**Addendum No. 3
Bid Date: Feb 13th, 2024
Plans, Specifications and Contract Documents
for
McCreary Co. Spec. Building Fit-up for
McCreary Co. Industrial
Development Authority**

ADDENDUM NO. 3 - ISSUE DATE: 2-8-24

MEP ADDENDUM #3

DRAWING NO.
M-1
SHEET OF

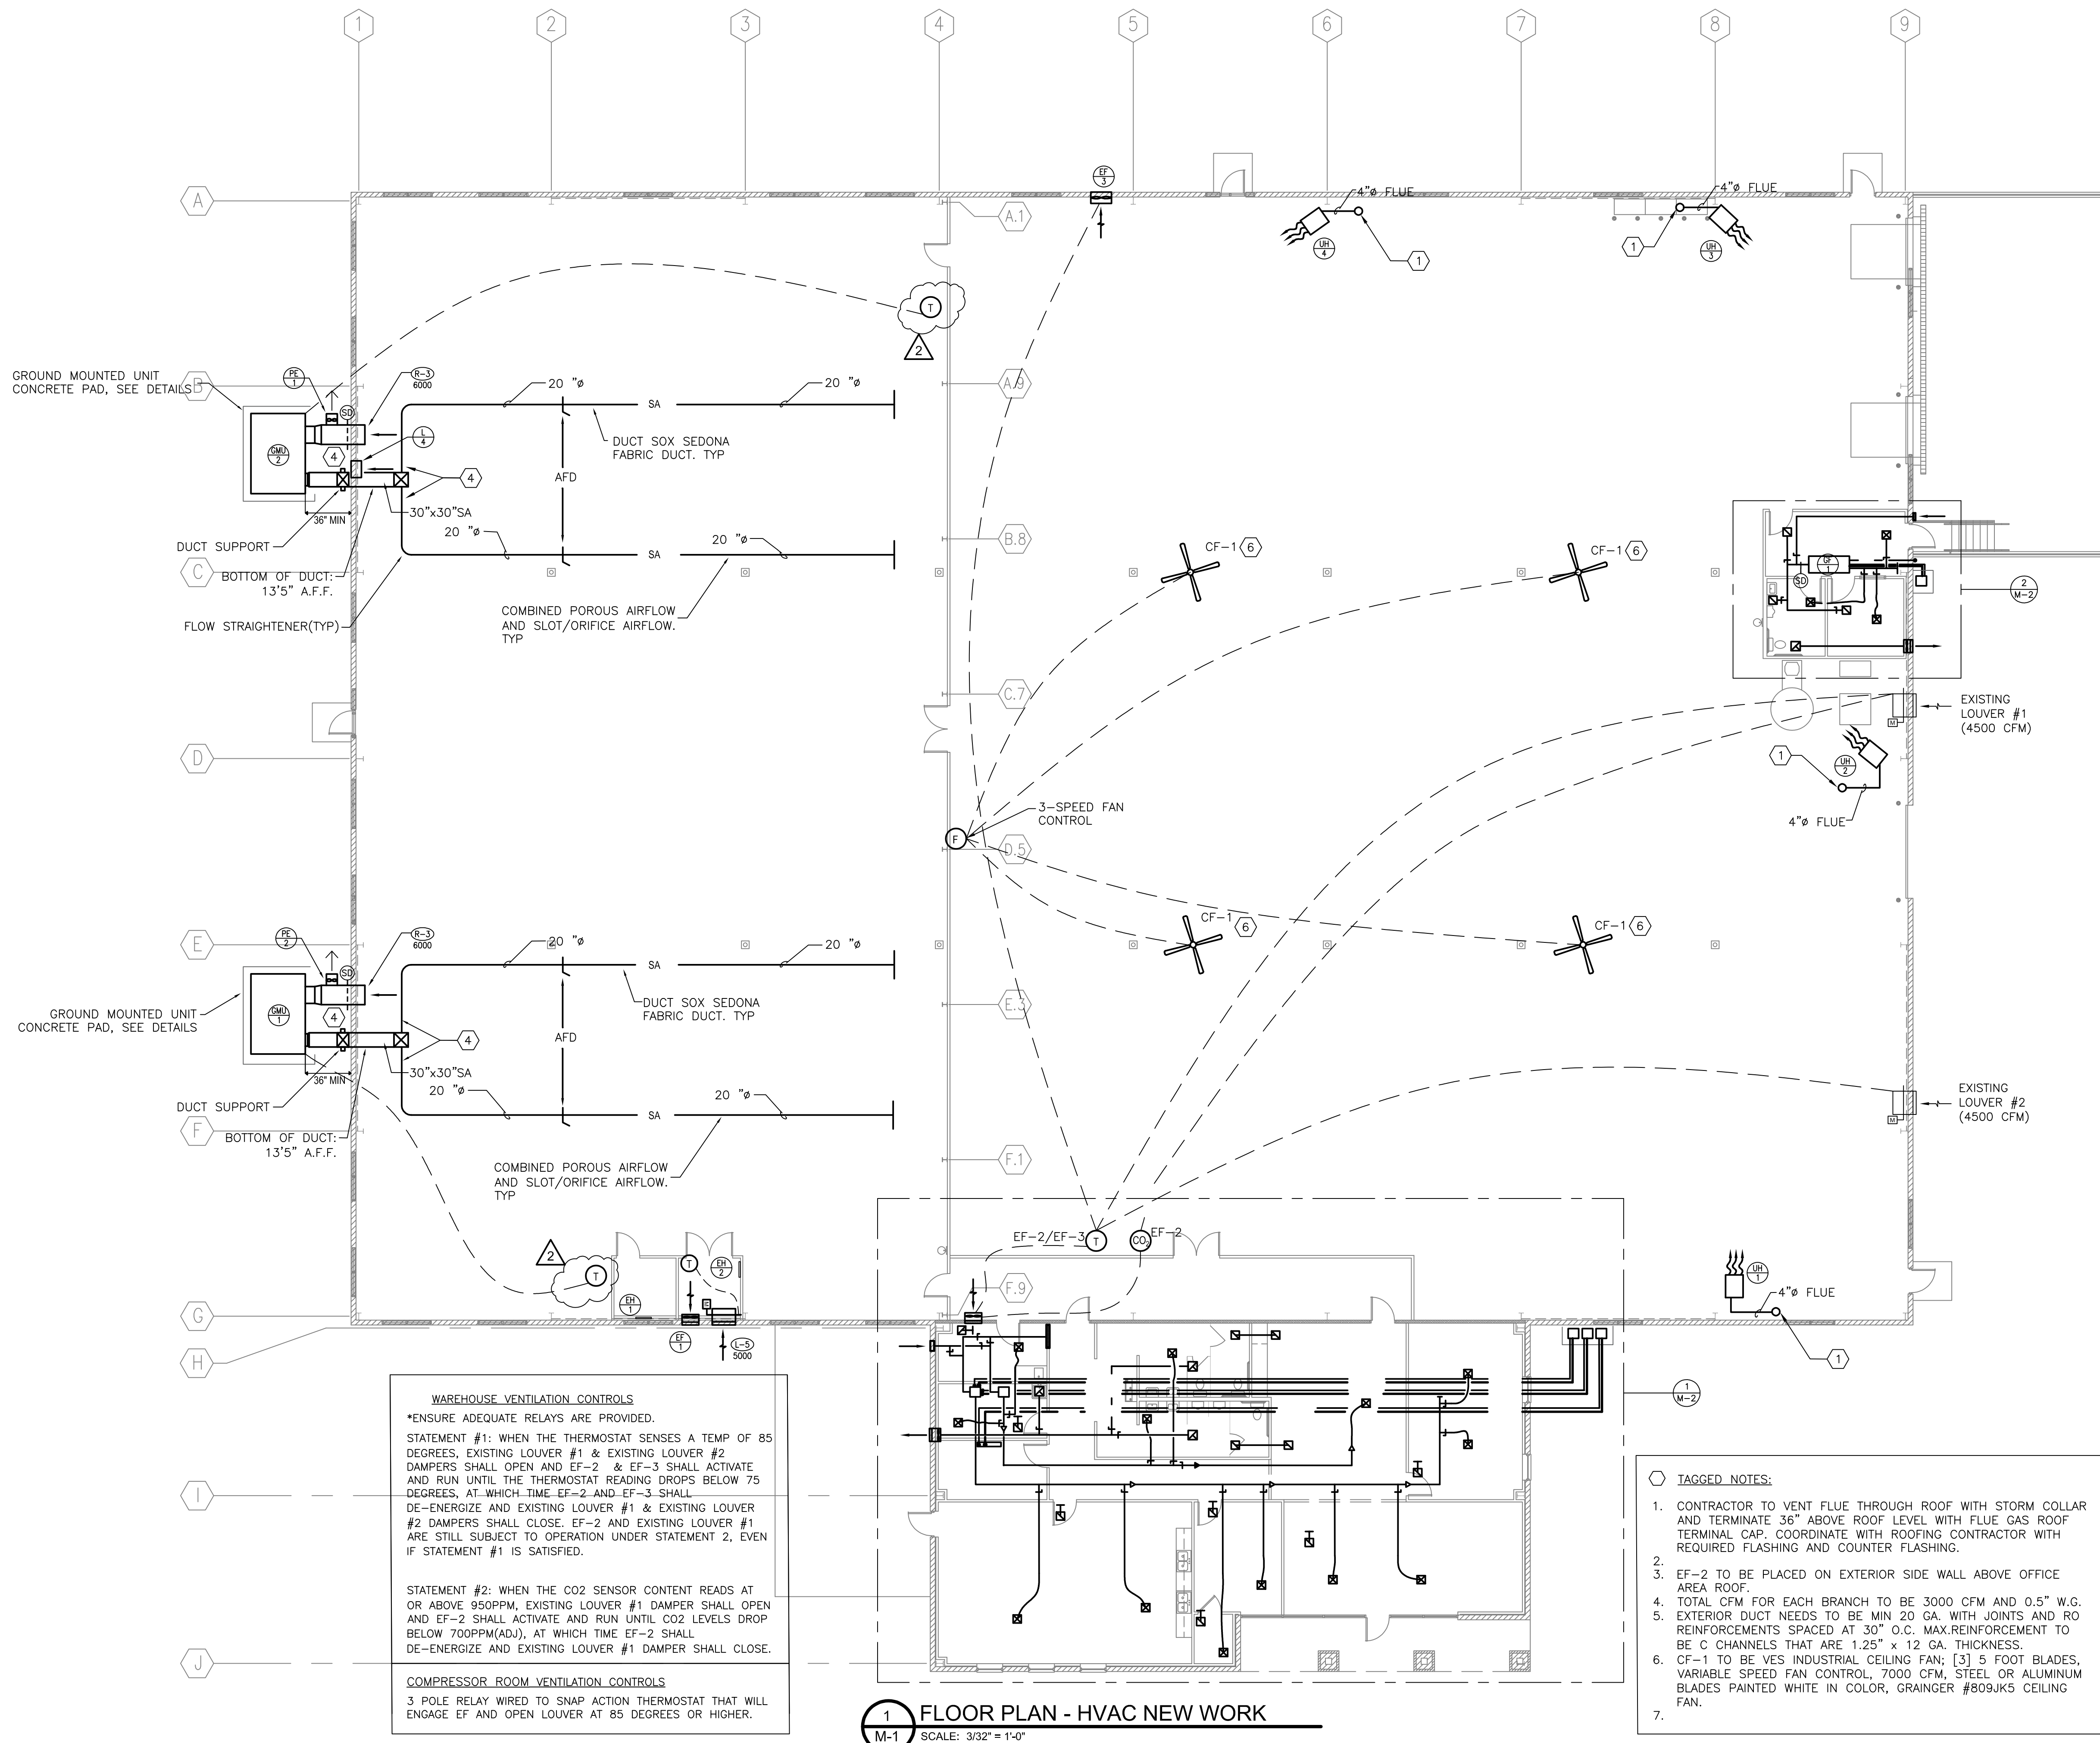
Item 1: Regarding HVAC thermostat locations and type, refer to specification 230900, and attached MPE Addendum #3 McCreary Co. Spec Building Fit-up, and updated attached sheets M-1 and M-2.

1. Please provide thermostats as indicated in attached drawings M-1 and M-2.
